Planning Director Staff Report– Hearing on September 29, 2022

JAIN RESIDENCE COASTAL PLANNED DEVELOPMENT (PD) PERMIT, CASE NO. PL17-0005

County of Ventura
Planning Director Hearing
Case No. PL17-0005
Exhibit 4 Mitigated Negative
Declaration, Comments and Staff's
Responses to Comments

PROJECT NO.
W464
 DRAWING NO.
W0.01
 SHEET 2 OF 3 SHEETS

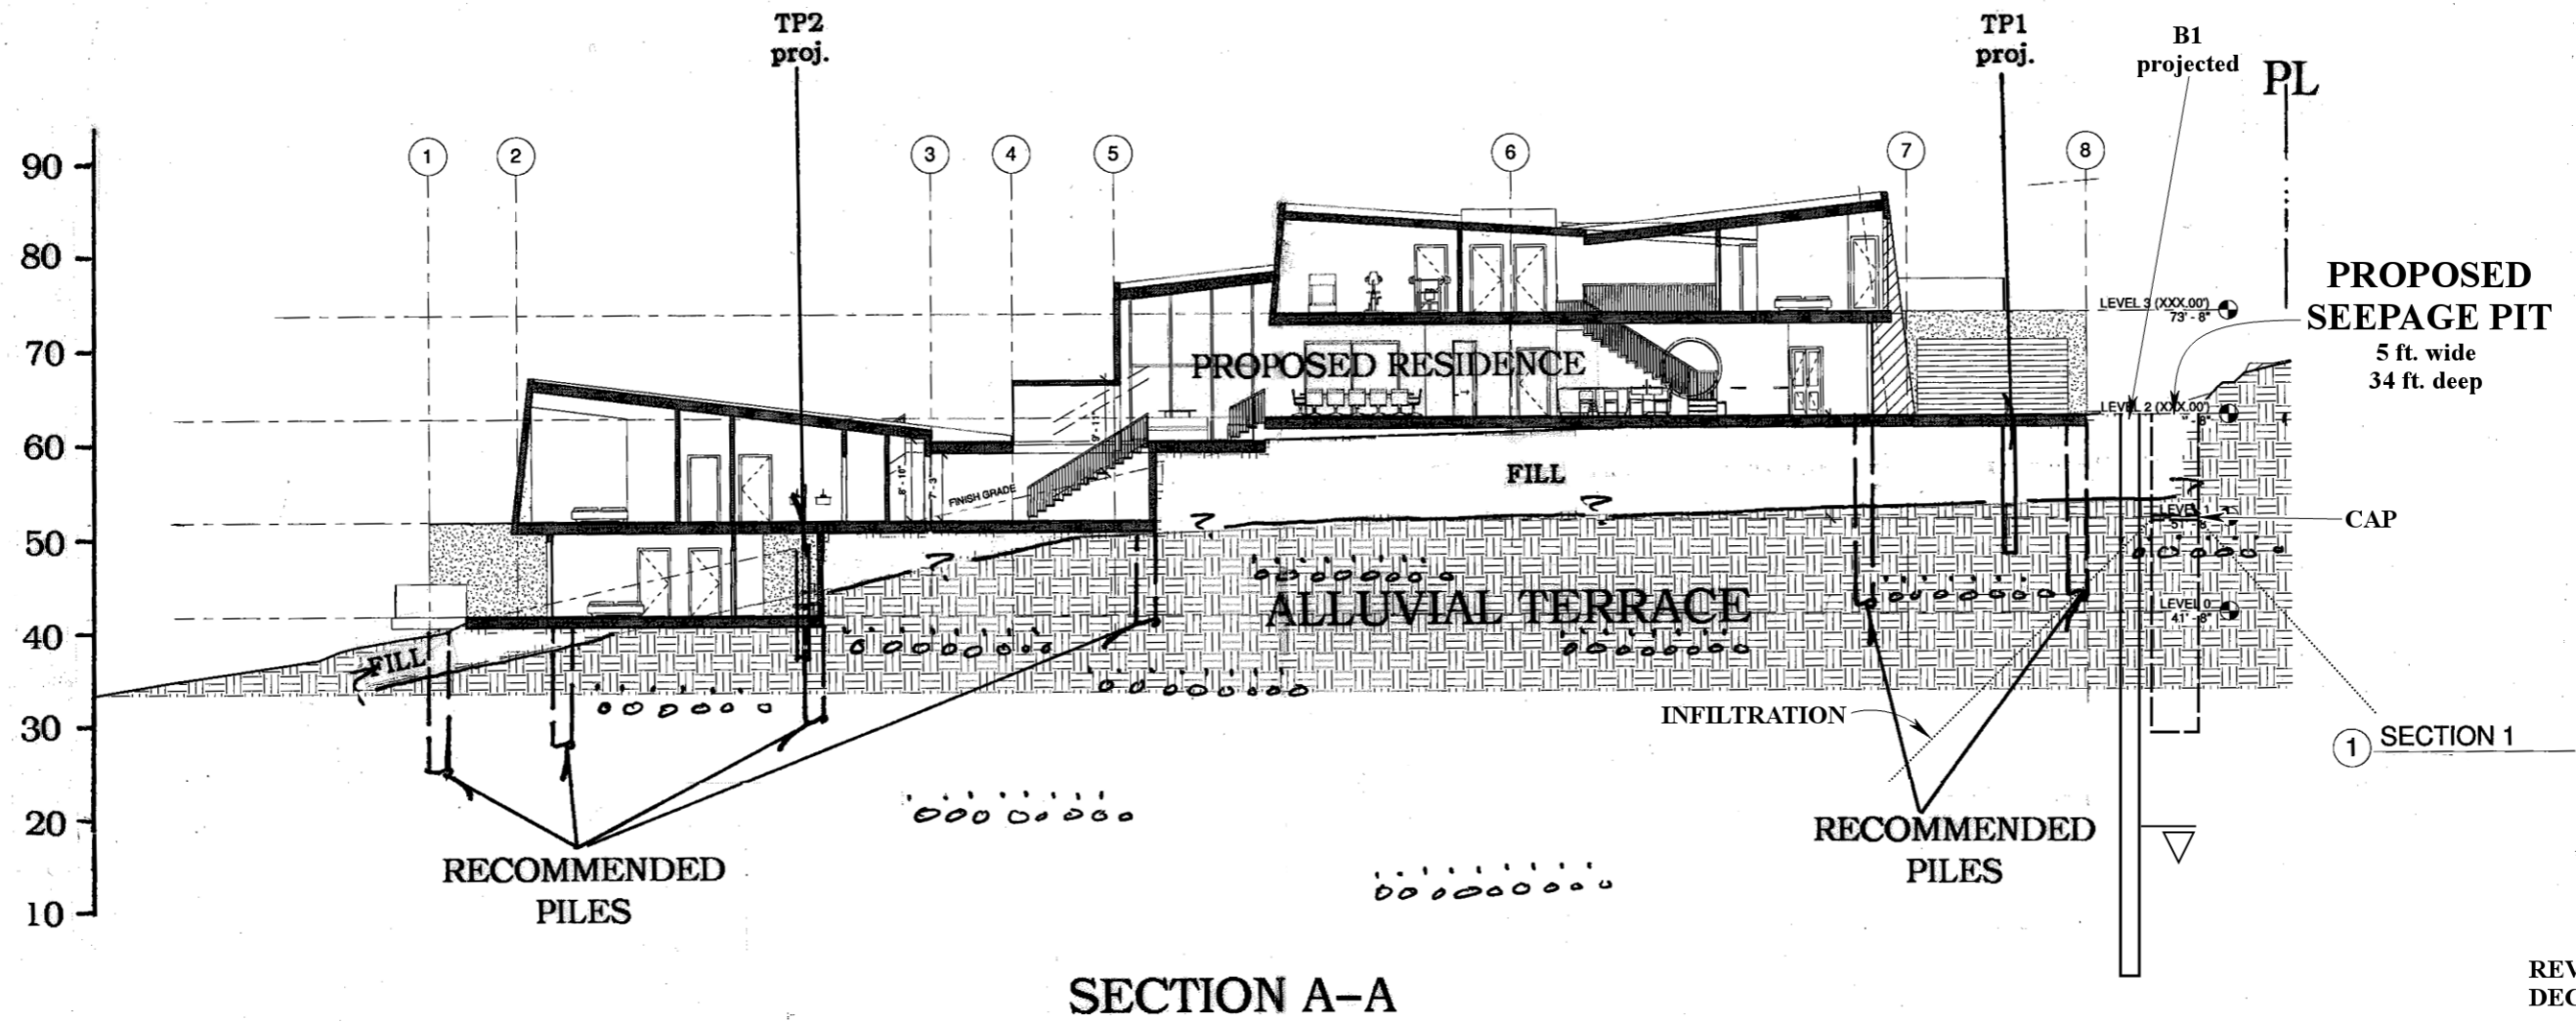
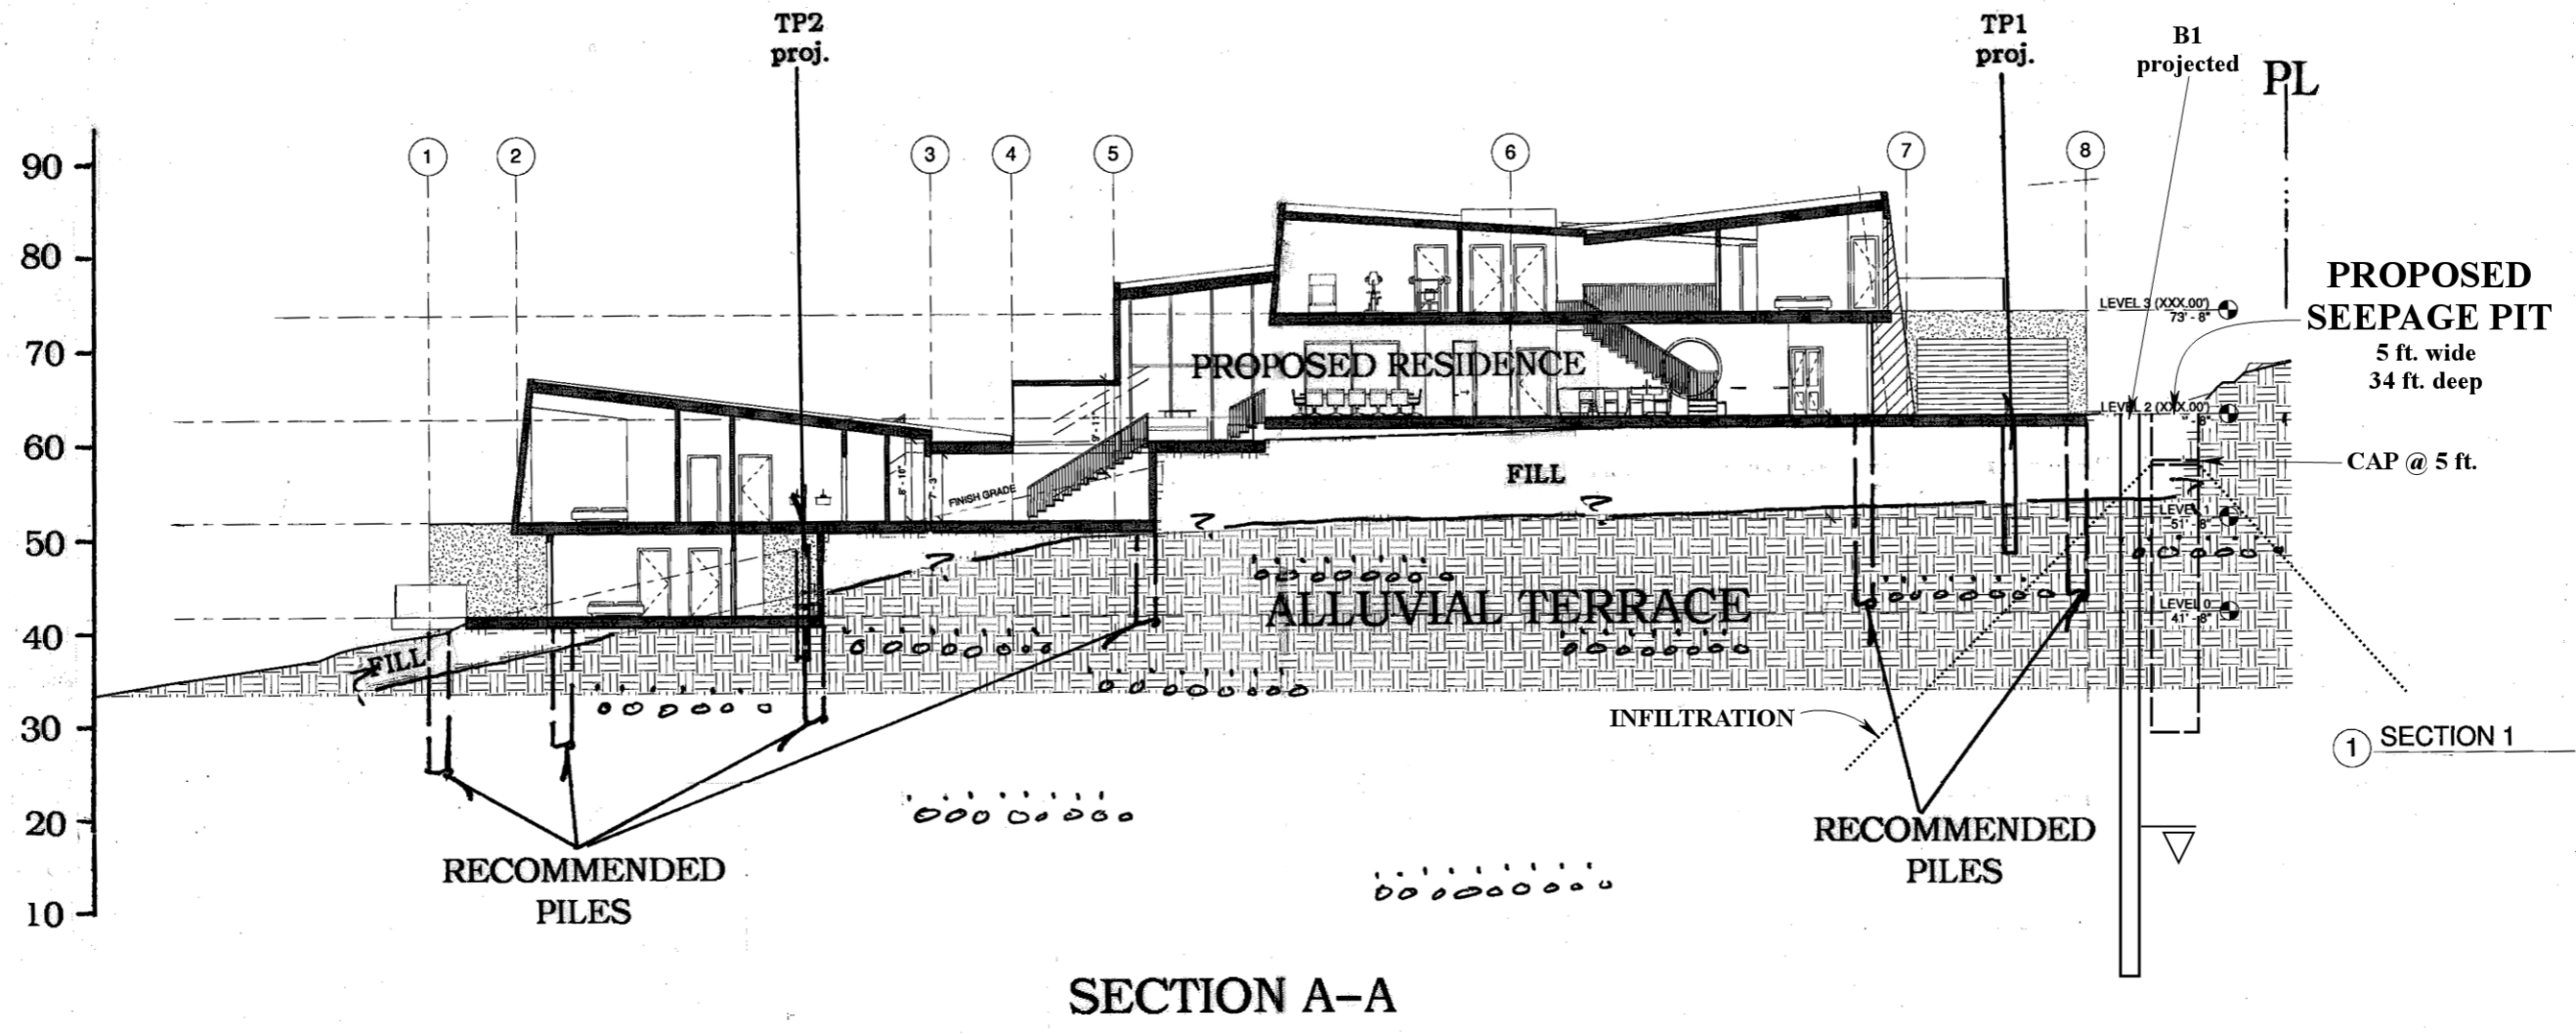
4. **Response to Comment 4:** The commenter states that the ISMND for the Project (Exhibit 4) was revised to address the stability of the slope area occurring on the site but failed to clarify if analysis by a qualified professional was completed in order to determine if this site constitutes a bluff, and to determine potential blufftop setbacks. In response to this item the Planning Division consulted with the Ventura County Public Works Agency (PWA) Engineering Geologist, Jim O'Tousa Certified Engineering Geologist CEG1393. Mr. O'Tousa previously conducted agency review of the Project on behalf of PWA for review of preliminary grading, geotechnical reports, and structural design. Mr. O'Tousa determined that based upon his review of the submitted project Plans (Exhibit 3) and the Geological and Soils Engineering Investigation (Exhibit 8), the site is stable, including manufactured slope areas. The Geological and Soils Engineering Investigation indicates that the subject property has been modified through previous grading activities and indicates the presence of fill material at a depth of 5 to 9 feet within the proposed

development envelop (See Drawing W0-01 for test pit locations, Exhibit 8). Mr. O'Tousa has reviewed the Geological and Soils Engineering Investigation and concurred with the determination in the report that the proposed Project is grossly stable to a factor of safety in excess of 1.5 (static) and 1.1 (pseudo static). Consistent with the applicable requirements of the Local Coastal Program and the January 16, 2003 Memorandum from Mark Johnson, Staff Geologist to the California Coastal Commission¹, the slope areas present on the Project site are stable, do not constitute bluff, and no slope setback is necessary for the Proposed project. As analyzed by Mr. O'Tousa, while the site contains sloping segments with flat segments (4 segments measured on Exhibit 3, Sheet C2.3), it does not contain any sheer or defined bluff face and is not presently subject to retreat or erosion. The toe of the manufactured sloping segment defined by Mr. O'Tousa is approximately 235 feet landward of the October 28, 2016 surveyed Mean High Tide Line and outside of the areas determined to be subject to Coastal Hazards (Exhibit 7). Consistent with the findings and analysis with the Planning Director Staff Report and its exhibits, the proposed single-family dwelling and ADU may be constructed as proposed consistent with the requirements of the Local Coastal Program and Coastal Act.
